Executive Director's Recommendation

Commission Meeting: April 4, 2019

PROJECT Walter E. Washington Convention Center - Exterior Alterations and Streetscape Improvements 801 Mount Vernon Place, NW Washington, DC	NCPC FILE NUMBER 7973
SUBMITTED BY Events DC	NCPC MAP FILE NUMBER 31.20(38.00)44899
REVIEW AUTHORITY District Projects in the Central Area per 40 U.S.C. § 8722(b)(1) and (e)	APPLICANT'S REQUEST Approval of preliminary and final site and building plans
	PROPOSED ACTION Approve preliminary and final site and building plans
	ACTION ITEM TYPE Staff Presentation

Wayfinding for Preliminary and Final Review

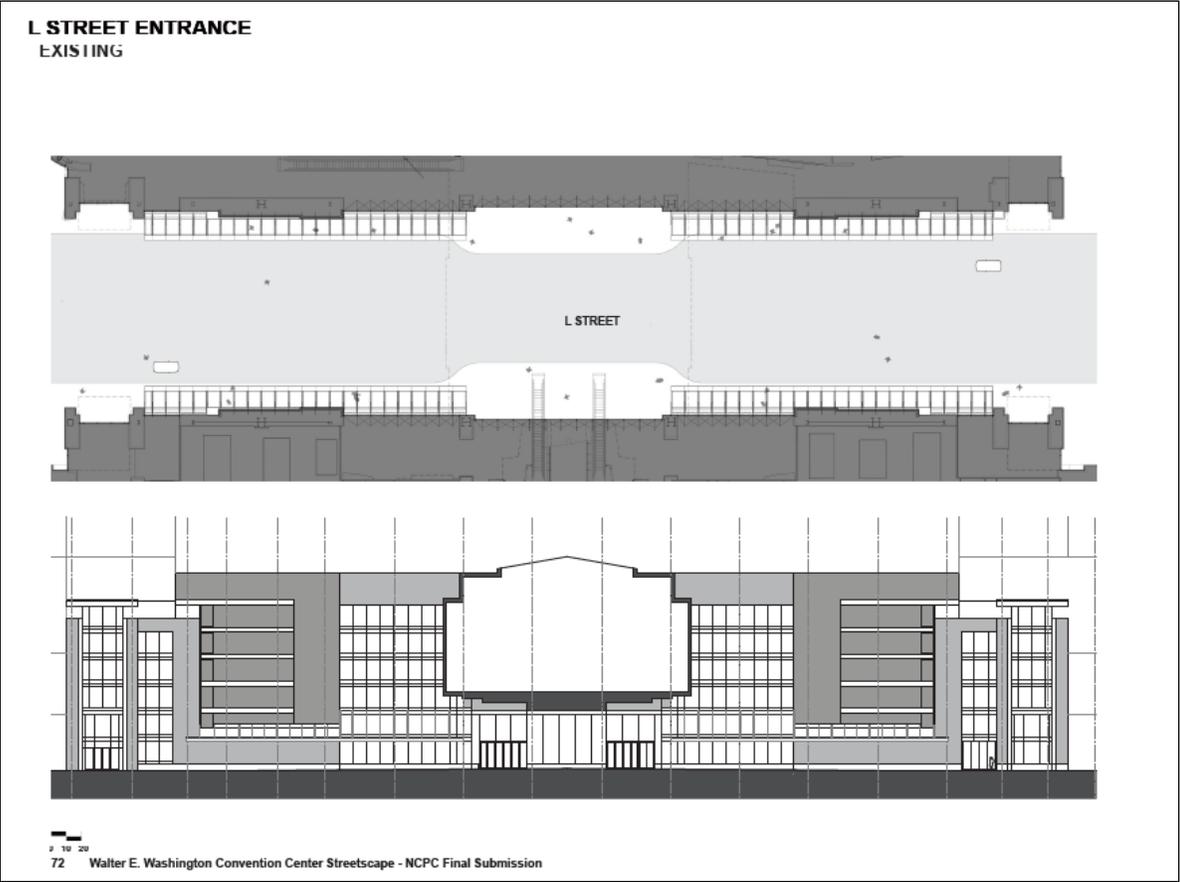
3. Updated
Color of the signage has been changed to a red which corresponds more closely to the materiality used throughout the project

Proposed Mt. Vernon Place Entrance Pylons

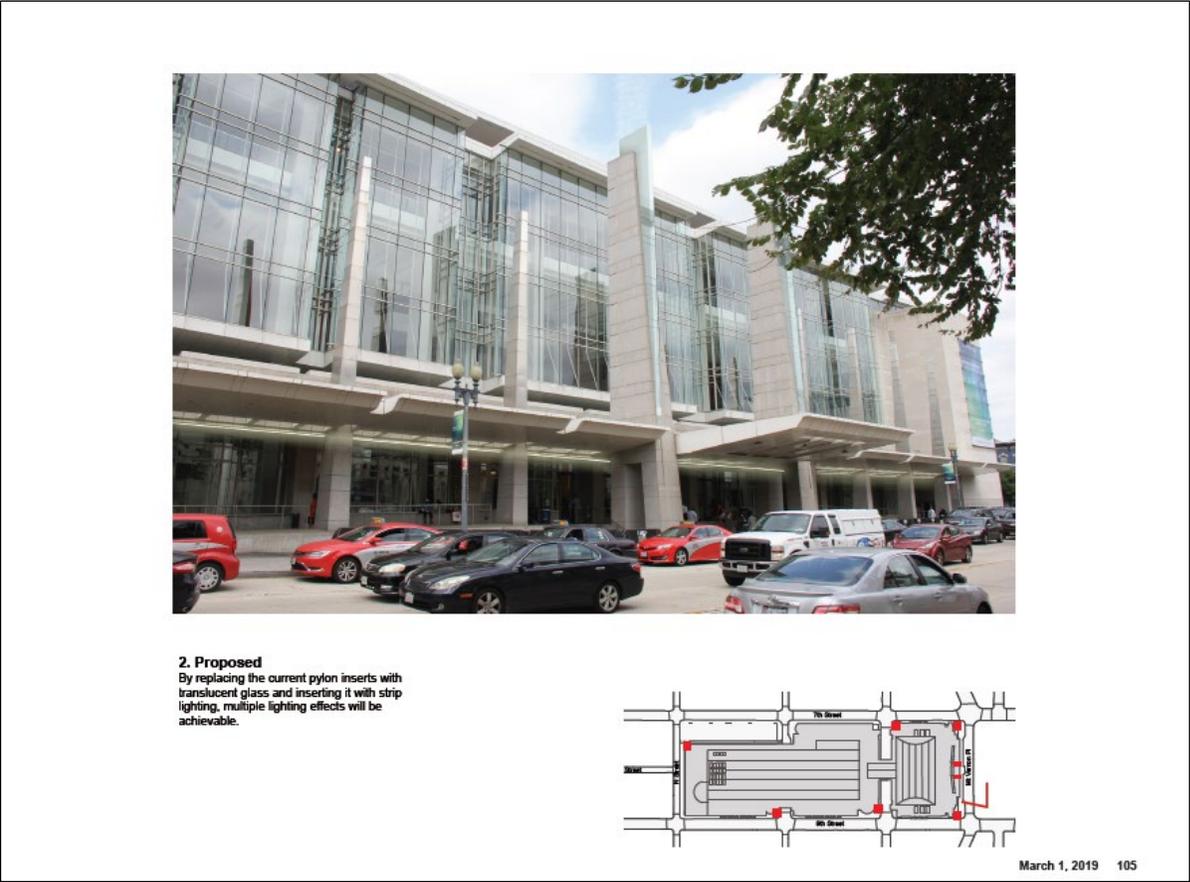
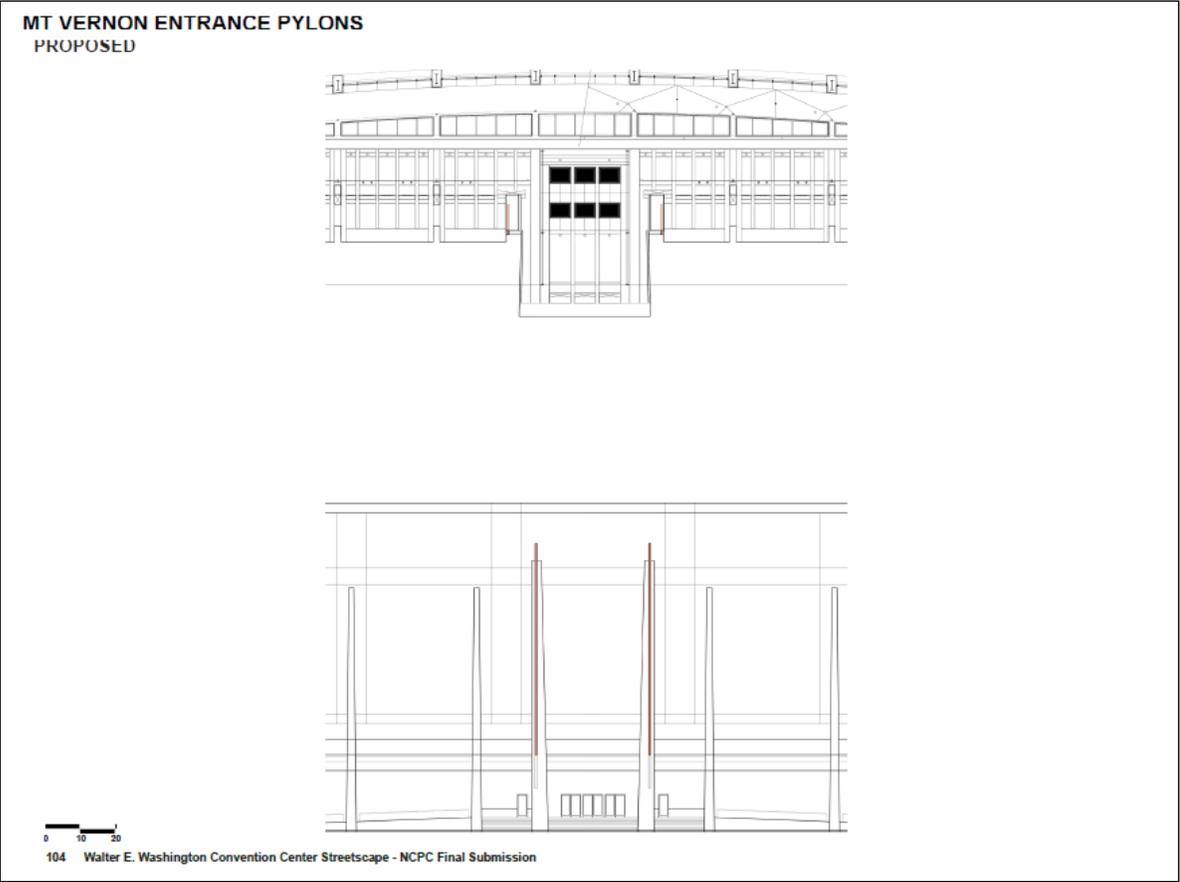
Currently, the pylons framing the Mt. Vernon Place entrance are not light emitting and must be projected onto in order to light up at night. The plan proposes to replace the current pylon inserts with translucent glass and inserting it with strip lighting, which would allow for multiple lighting effects.

1. Existing Condition
The current pylons framing the Mt. Vernon Entrance are not light emitting, and must be projected onto in order to light up at night.

Proposed Exterior Lighting Scheme

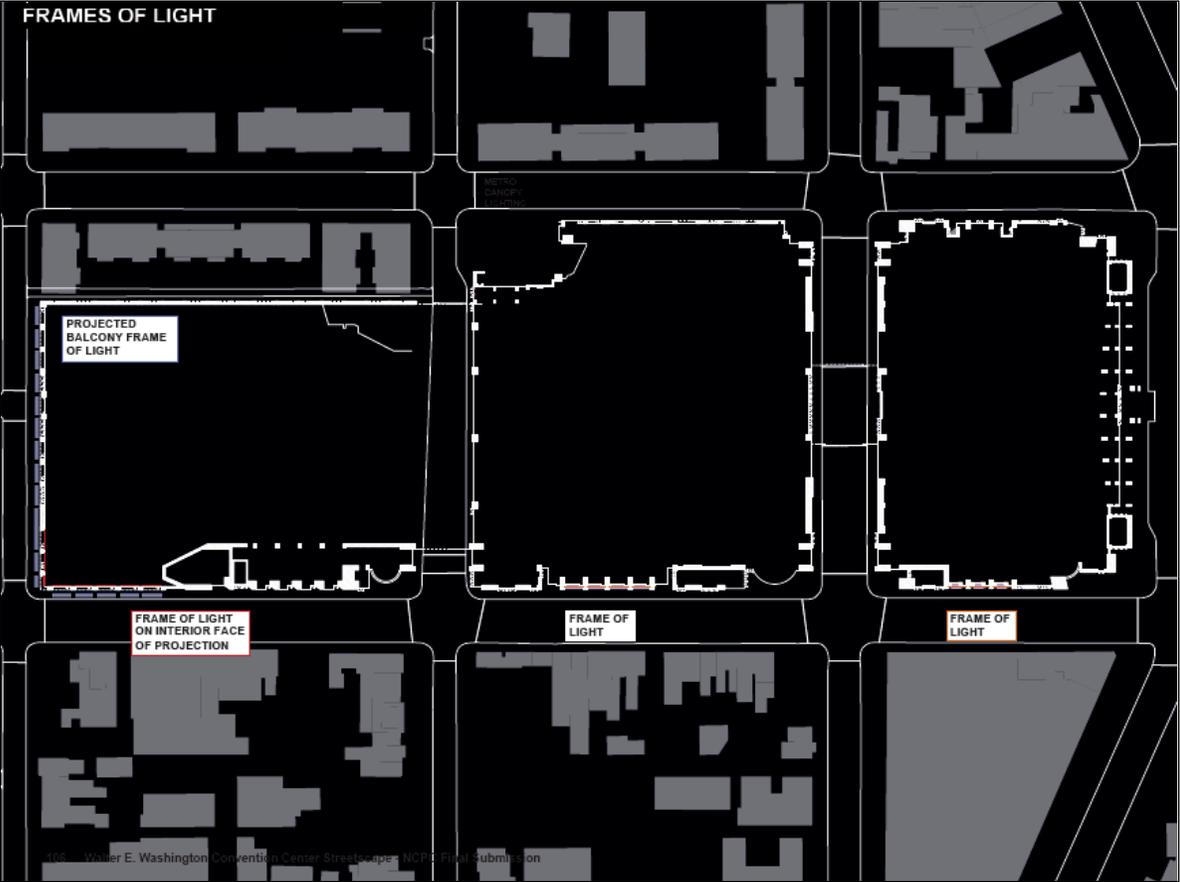
Regarding the proposed exterior alterations of the retail kiosk and the projecting balconies, the plan suggests the use of linear lensed LED strips to outline these features, with color lighting. Red will be used for the kiosks and yellow strips for the balconies. The new roof top terraces are proposed to have step lighting, garden uplighting, and floor mounted lights. Washington Globe streetlamps will be used along the streets encompassing the Convention Center, with additional lighting for the new wayfinding and street planters (linear sidewalk downlighting).
